HORSHAM DISTRICT COUNCIL CONSULTATION

TO:	Horsham District Council – Planning Dept
LOCATION:	Land To The Rear of The Copse Worthing Road Horsham West Sussex
DESCRIPTION:	Construction of up to 23 residential dwellings, (including 9 affordable homes), including access, parking, landscaping and other associated infrastructure works.
REFERENCE:	DC/26/0355
RECOMMENDATION:	Holding Objection / More Information / Modification

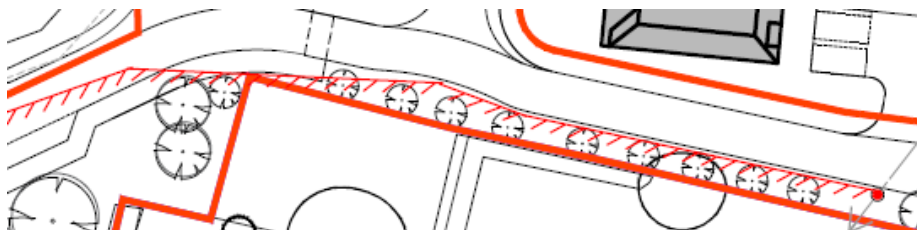
20. The current layout appears set too close to the RPA's of the boundaries as discussed at para 12 with no opportunity to enhance given proximity of dwellings and sizes of gardens? Please demonstrate how this measure is to be delivered.

Not addressed; please see point 2c.
